# Optimization of the MPGD layers of EPIC detector

**EPIC Detector Tracking WG**

**December 01, 2022**

# EPIC reference detector : Question 1

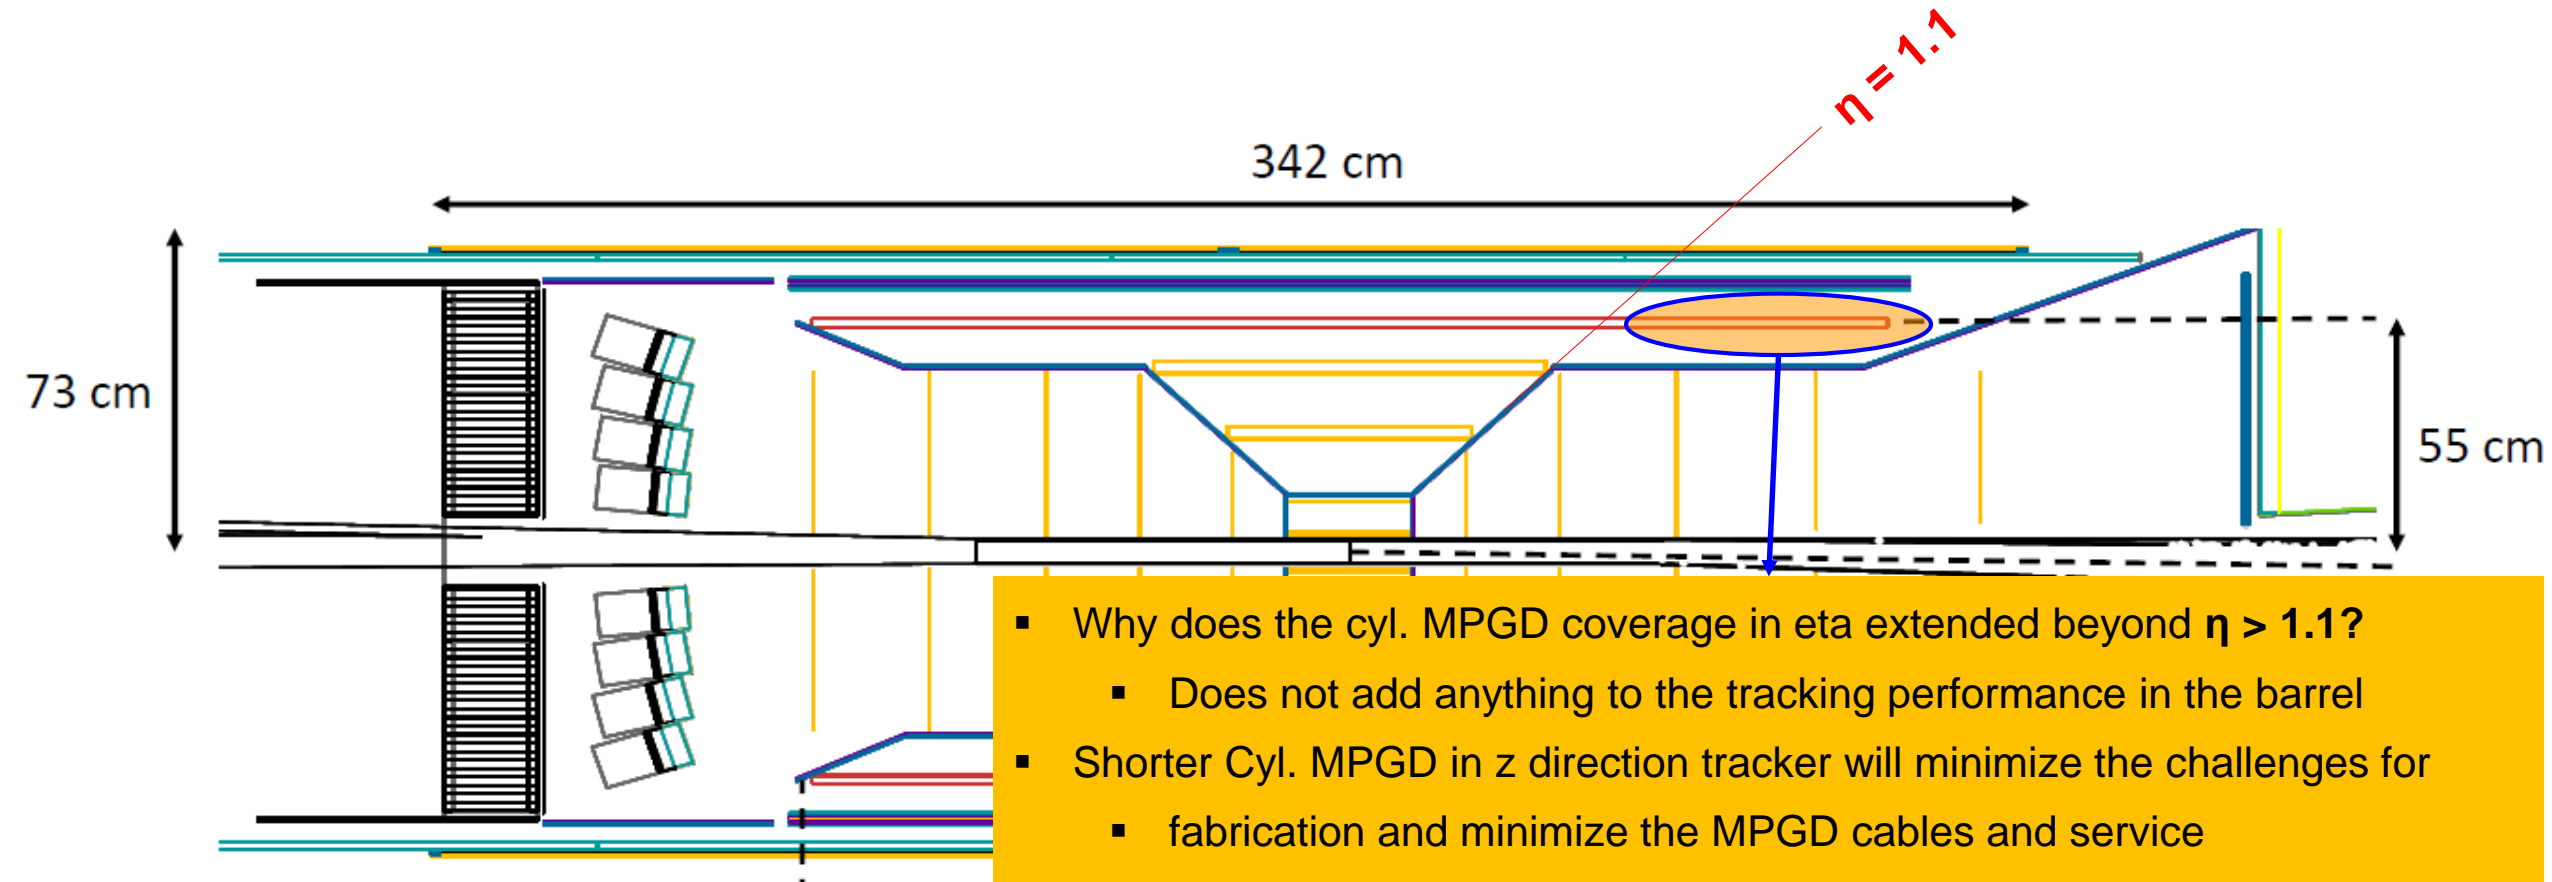
What is **the role of the single cyl. MPGD** in the current configuration of ePIC reference detector?

1. What is the contribution to tracking in term momentum and transverse point resolution?
  - **Ongoing simulation effort should evaluate so that we reach a consensus on this question**

2. Are the Cyl MPGD layer (and TOF layers) mainly for pattern recognition in support of the main Si trackers?
  - Minimum number of tracking layers required for pattern recognition

- **Need simulation with background to make this determination**
3. Is the MPGD layer together with the TOF layers for redundancy
  - to recover for missing hit from the Si trackers (dead pixels ...)

- **Ongoing simulation effort should evaluate the impact on overall tracking performance**
4. Why do the MPGD and TOF cover an  $|\eta|$  up to 1.5 and not limited to 1.1

- Impact on the Si support structure and services
  - Impact on tracking performance in the forward and backward endcap

# EPIC reference detector: Possible option to question 2

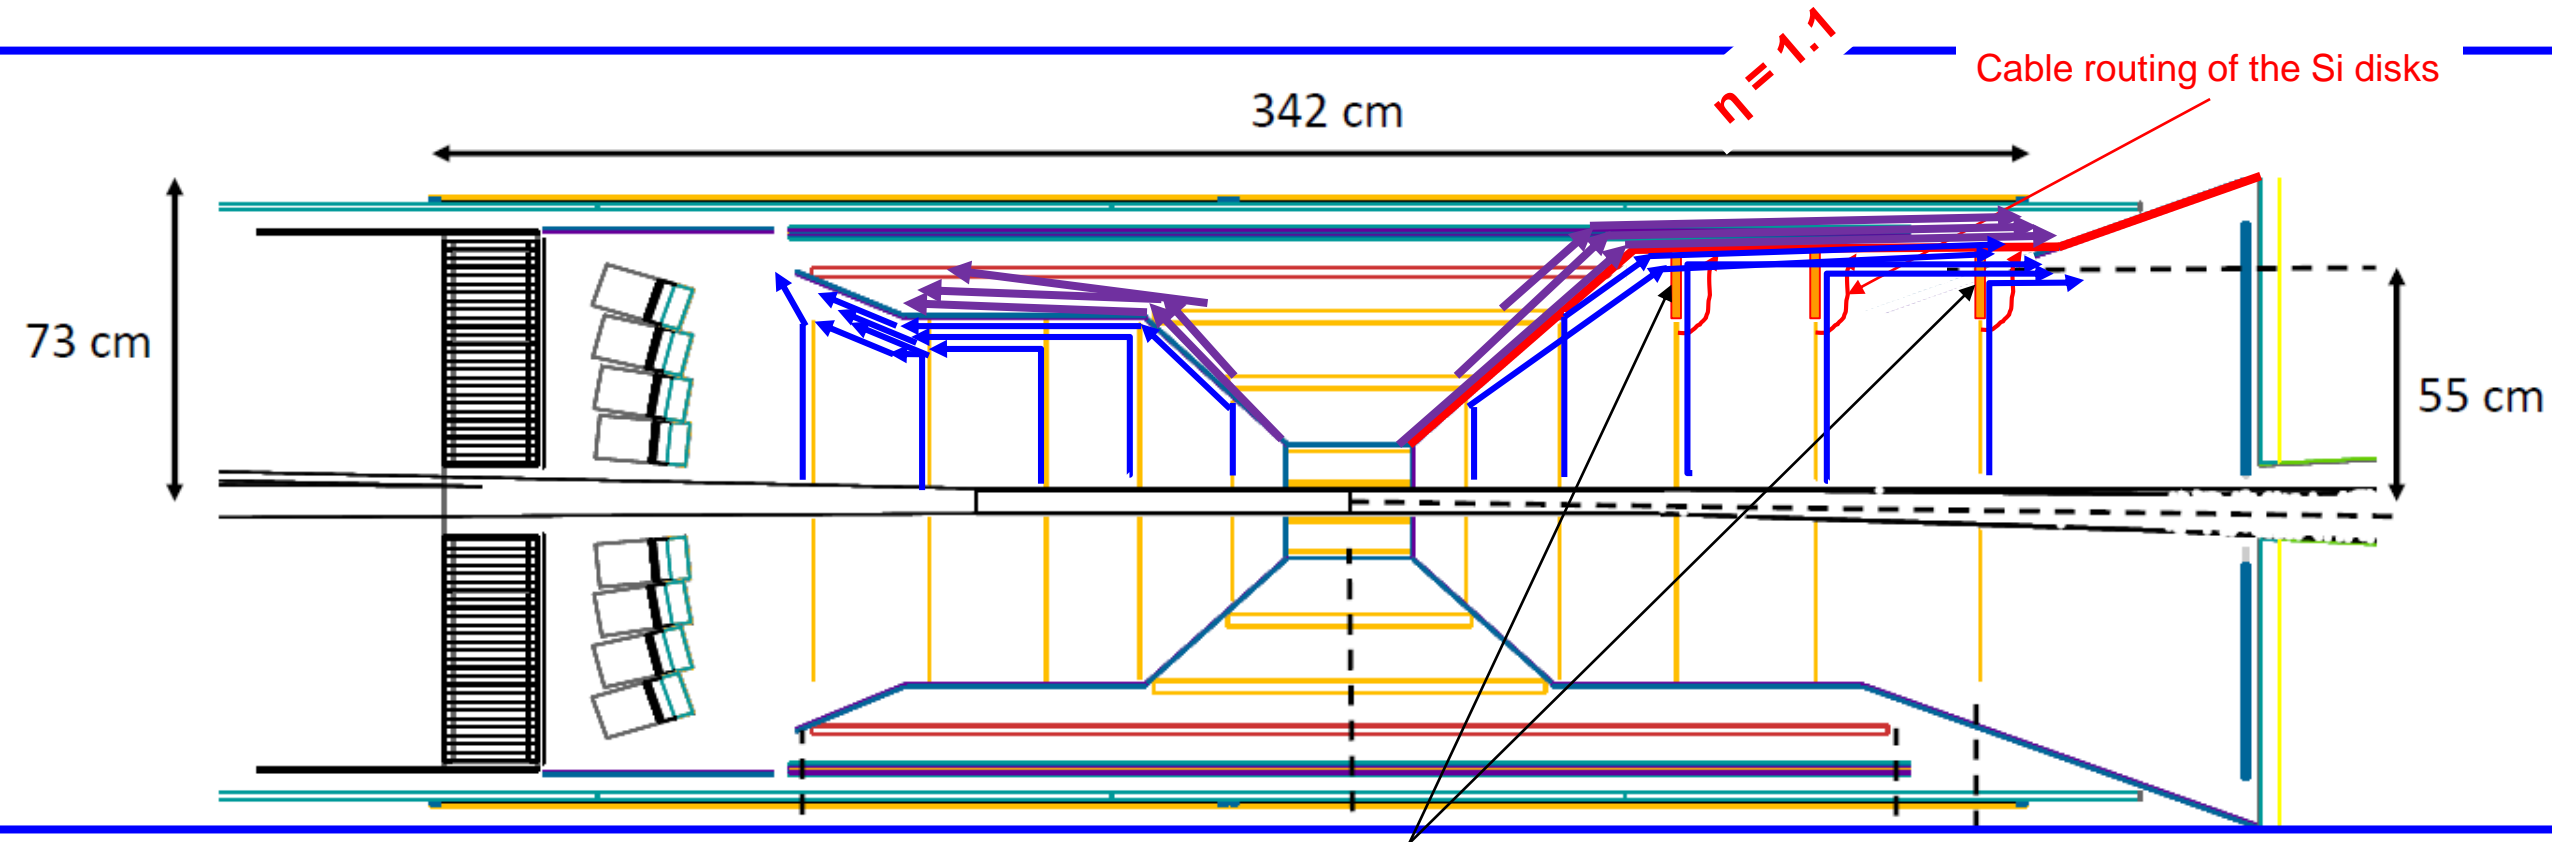
- Why does the cyl. MPGD coverage in eta extended beyond  $\eta > 1.1$ ?
  - Does not add anything to the tracking performance in the barrel
- Shorter Cyl. MPGD in z direction tracker will minimize the challenges for
  - fabrication and minimize the MPGD cables and service
- As layer providing additional space point for both end cap Si-trackers
  - Poor space point resolution → because of large track angles ( $> 45^\circ$ )
  - Material of the Si support cone structure in front of the layer ...
- **Similar argument can be held for the AC-LGAD disk**
  - **But this is a discussion for another day**

- Complement the Si disks with thin gap MPGD rings (or extending Si disks radius)
- Optimizing the Si-layer cable and services “cone” support → (red lines)
- Could the cables of the Si-disks be routed vertically up to the cone structure?
  - This will be optimal for performances

# EPIC reference detector: Possible option to question 2

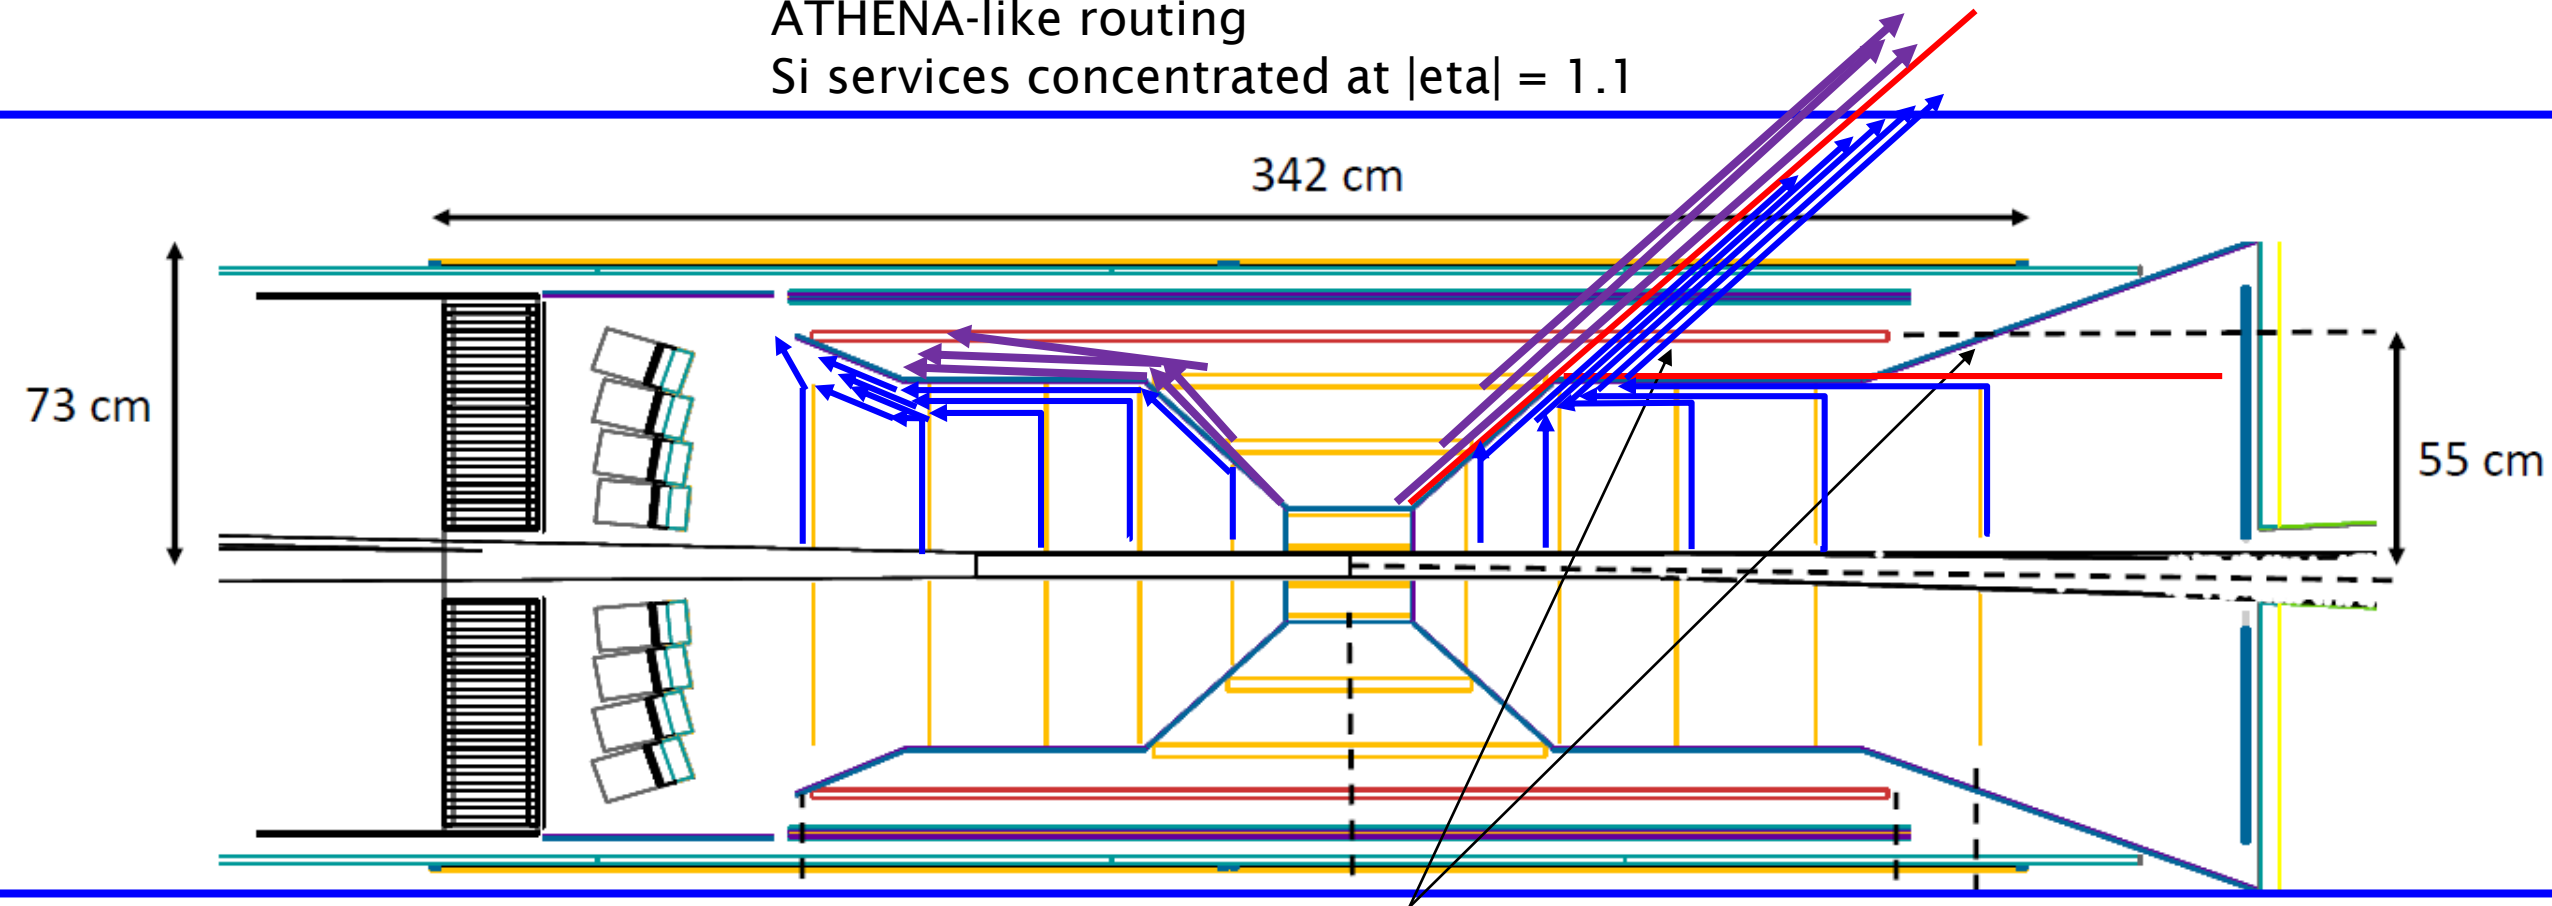
ATHENA-like routing  
Si services concentrated at  $|\eta| = 1.1$

- Complement the Si disks with thin gap MPGD rings (or extending Si disks radius)
- Optimizing the Si-layer cable and services “cone” support → (red lines)
- Could the cables of the Si-disks be routed vertically up to the cone structure?
  - This will be optimal for performances

# EPIC reference detector : Question 3 – MPGD layer behind dRICH

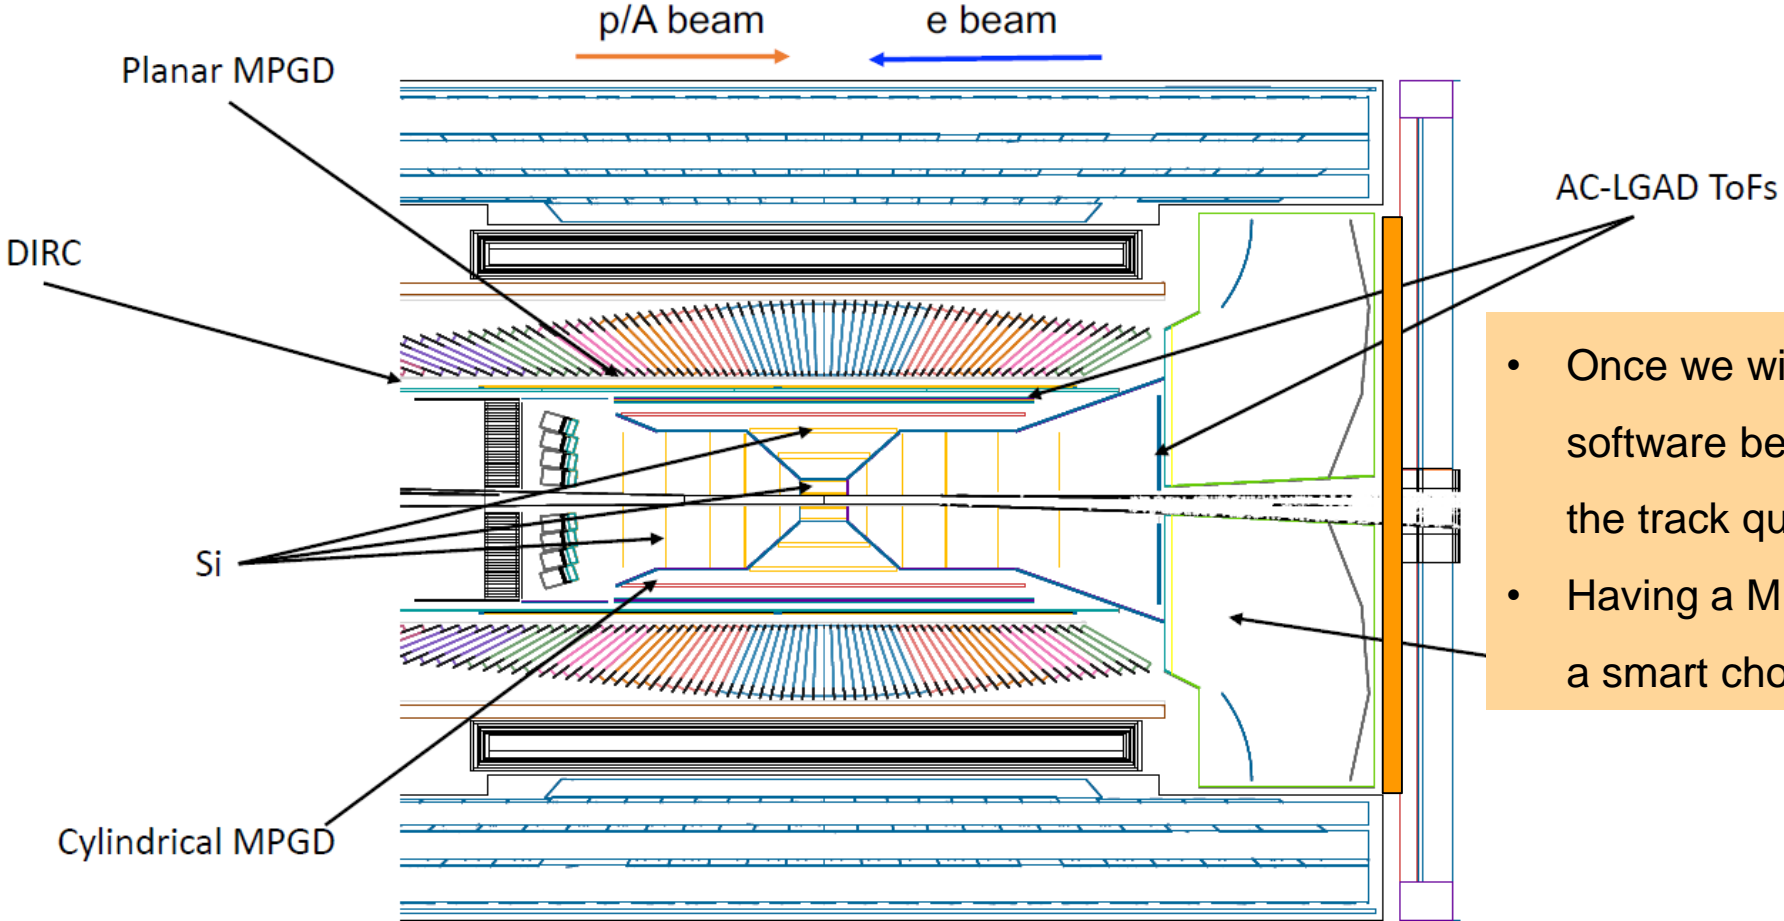
- Once we will have the background and the software becomes more mature, we will re-assess the track quality extrapolated inside the dRICH
- Having a MPGD layer after dRICH is still probably a smart choice
